# DAWN LEA PARTY IN OPPOSITION BZA APPLICATION NO. 20380

JULY 14, 2021

*Common attic of 4457 – 4459*

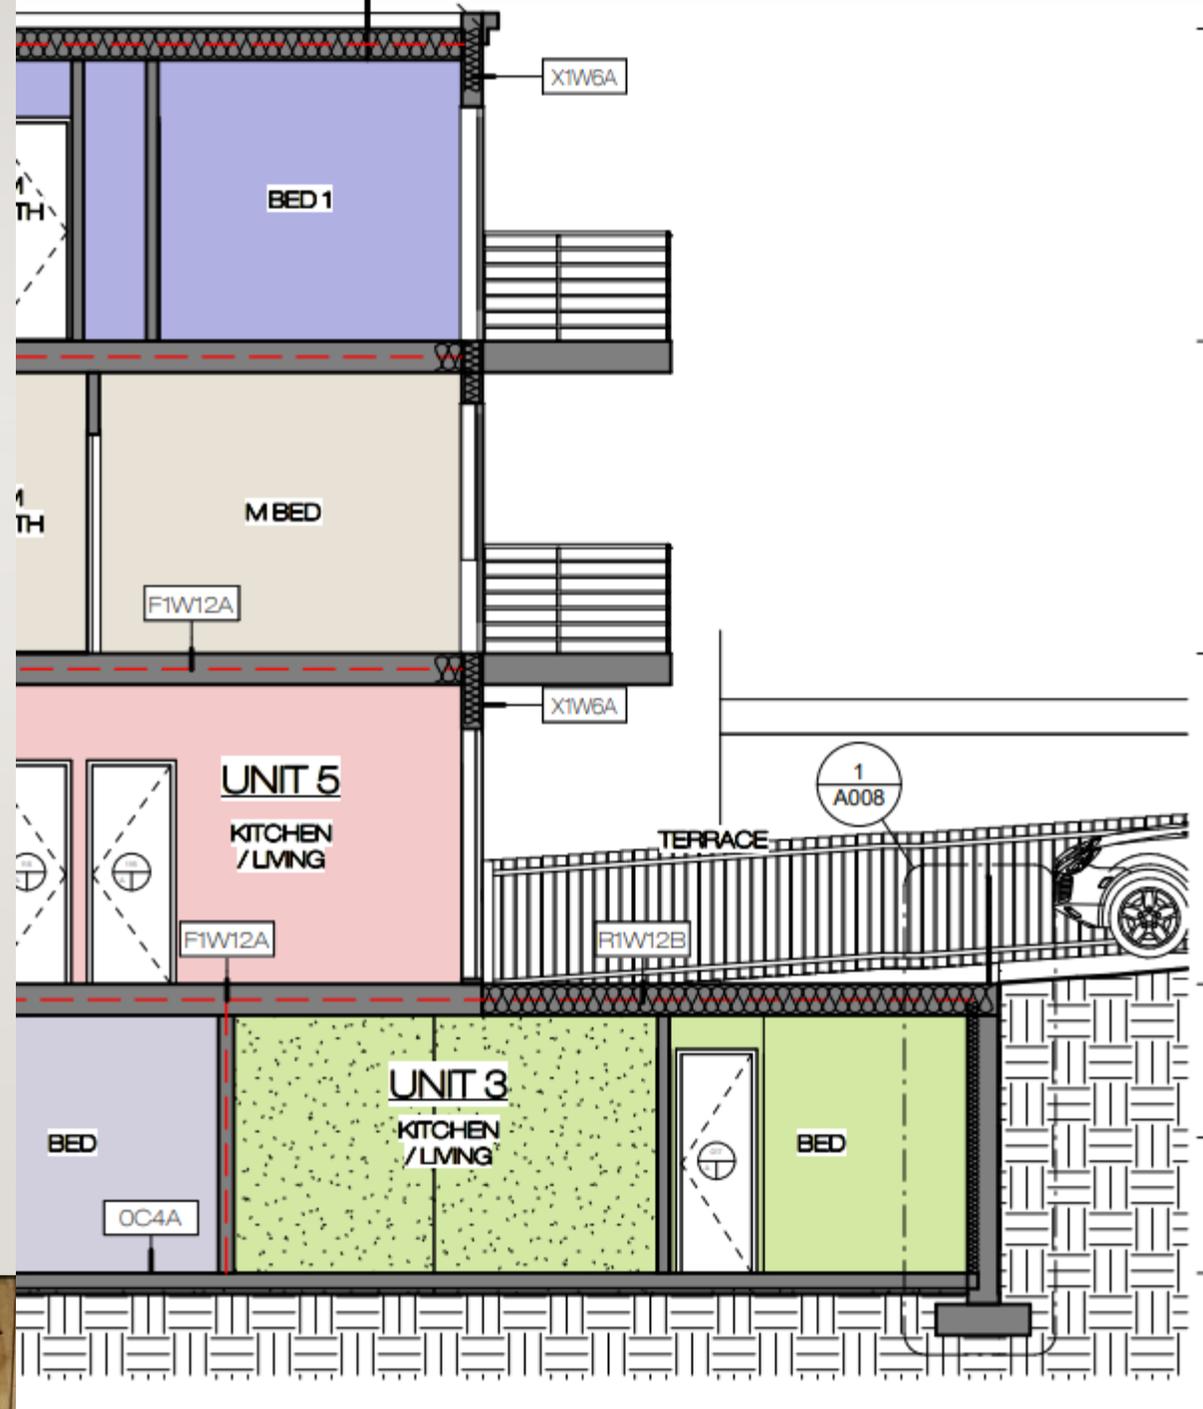
*Arrow indicating the attic vent for 4457 when viewed through 4459 side of the attic.*

- There is a liveable finished basement at 4459 which has never been addressed in any renderings. The ‘basement’ begins beneath the front porch. This is of concern due to proposed ‘cellar’ units at 4457 and underpinnings for structure.
- The 4459 garage roof is overlapped by 8 inches from the garage at 4457.
- There is a 3 ft thick concrete area at the rear of the existing house at 4457, hence the ‘step up’ in the rear of the house. What protections are going to be made at 4459 to maintain integrity when demolishing said concrete.

## 17 STRUCTURAL ISSUES – ENGINEER'S REPORT ON REVISED DRAWINGS

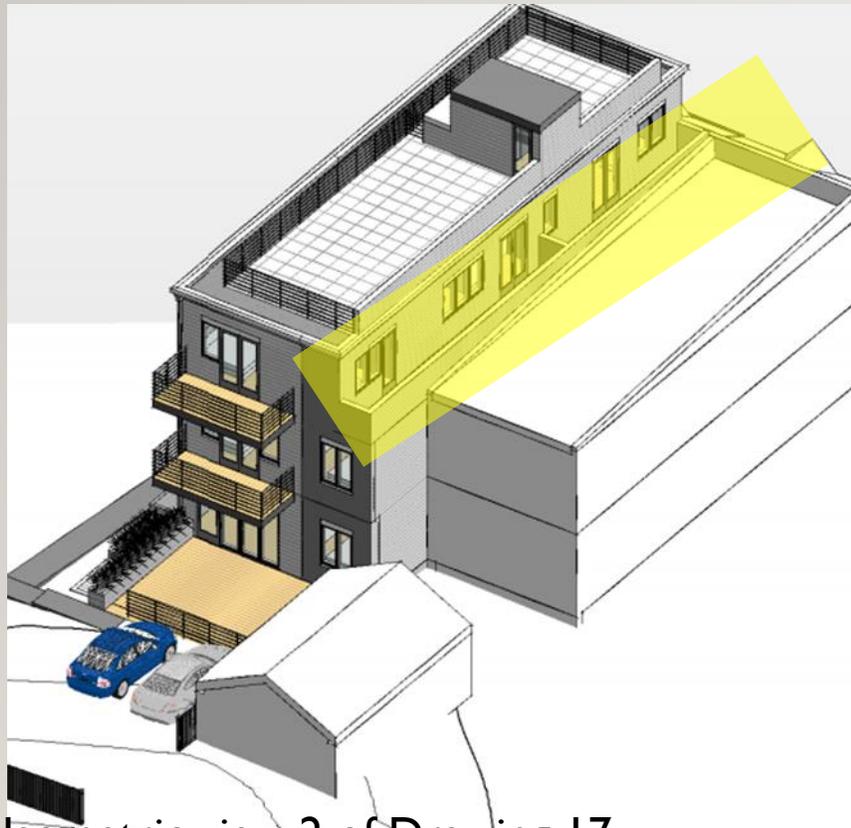
1. Despite set back on the last floor, the Snowdrift issue is not eliminated. The parapet on the upper floor will still cause snow drift accumulation. This is obvious in Isometric view 2 of Drawing 17, Cross Section 3 on Drawing 14, and Cross Section 2 on Drawing 13.

The snowdrift horizontal length is 6.5 feet. Therefore, any obstacle placed within 6.5 feet of the property line will cause snowdrift accumulation.

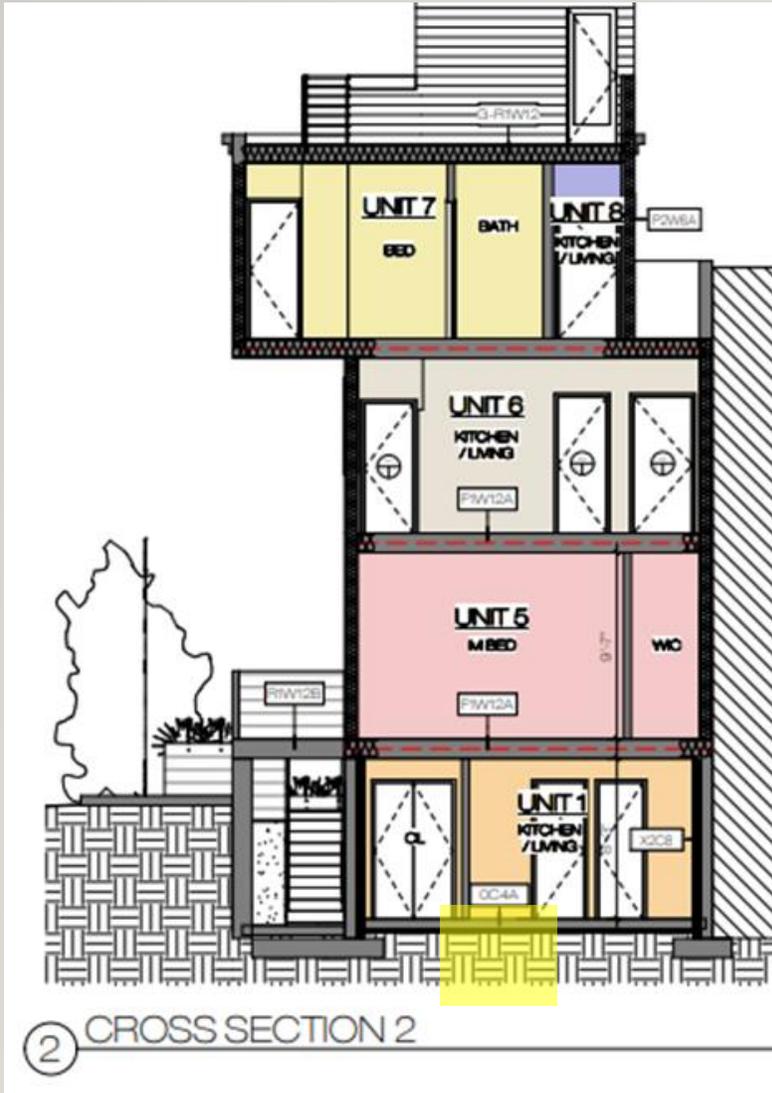
2- The full set of plans are not submitted. The plans do not show the dimensions. The developer shall provide the full set for our review.

3- Per my observation in my site visit, the area at the rear of your property is missing studs and proper supports. Demolition of the neighbor’s property will seriously jeopardize the wall and expose your interior space to weather, frost, humidity, and heat.

4- It is not clear how the underpinning will be done in the basement. The plans shall show the extent and depth of underpinning. Cross Section 2 of Drawing I3 and Cross Section 3 of Drawing I4 show the new foundation encroaches into your property. The new foundation section and plan are required to show the new footing will not pass beyond the surface of the party wall.
